Rezoning Transportation Analysis

Petition Number: 2022-155

General Location Identifier: 03715511

Date	Description
1-25-23	First Review (TM)

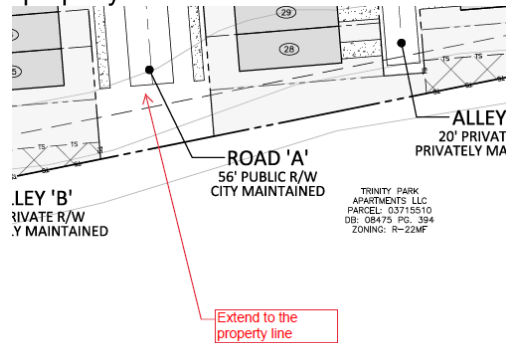
3. Revise site plan and conditional note(s) to commit to dedicate 28-feet of right-of-way from the road centerline of Roadway A. The site plan shall label and dimension the right-of-way from the road centerline.

4. Revise site plan and conditional note(s) to commit to construct an 8-foot planting strip, and 6-foot sidewalk on Road A per Chapter 19. The site plan shall label and dimension both items from the back of curb and gutter or edge of pavement.

5. Add a conditional note specifying "A Right-of-Way Encroachment Agreement is required for the installation of any non-standard item(s) (irrigation systems, decorative concrete pavement, brick pavers, etc.) within a proposed/existing City-maintained street right-of-way by a private individual, group, business, or homeowner's/business association. An encroachment agreement must be approved by CDOT prior to construction/installation. Contact CDOT for additional information concerning cost, submittal, and liability insurance coverage requirements."

6. Revise site plan and conditional note(s) to commit to completing a developer agreement with the active CIP project prior to permitting approval. Revise site plan to show the updated easement information and CIP project linework including streetscape and ROW that has been previously purchased.

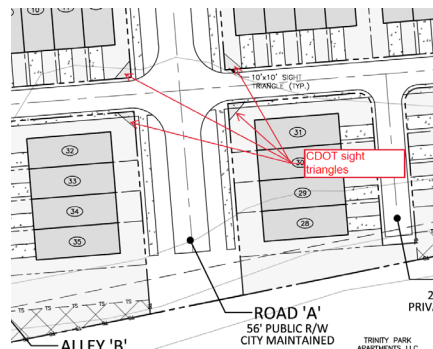
8. Revise site plan and conditional note(s) to commit to clearly identifying Road A as standard from the CLDSM. Add standard to the callout of road A as well as add a conditional note committing to constructing roadway A to a CLDSM standard. Site plan shall label and dimension roadway infrastructure from the roadway centerline including ROW.
9. Revise site plan and conditional note(s) to commit to clearly identifying Alley cross sections as a standard from the CLDSM. Add standard to the callout of alleyways as well as add a conditional note committing to constructing them to CLDSM standard.
10. Revise site plan by dimensioning the sidewalk along Alley A.
11. Revise site plan by adding CDOT sight triangles to the intersection of Alley A and Roadway A per CDOT sight distance policy. Show either the 50 x 50 sight triangle or the 35 x 35 sight triangle.
